Amendments to the Drawings

Appln. No. 10/791,702
Amdt. dated October 28, 2005
Reply to Office Action of July 28, 2005

ANNOTATED DRAWING SHEET SHOWING CHANGES

FIG. 2B

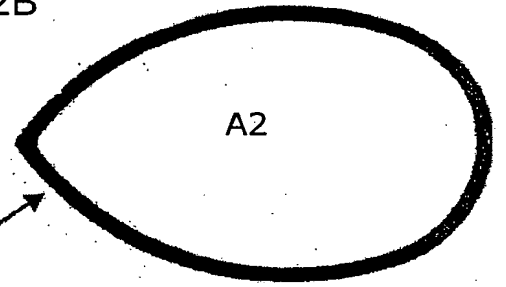
In Fig. 2A, improper use of shading has been removed. In Figs. 2B and 2C, improper cross-hatching has been corrected.
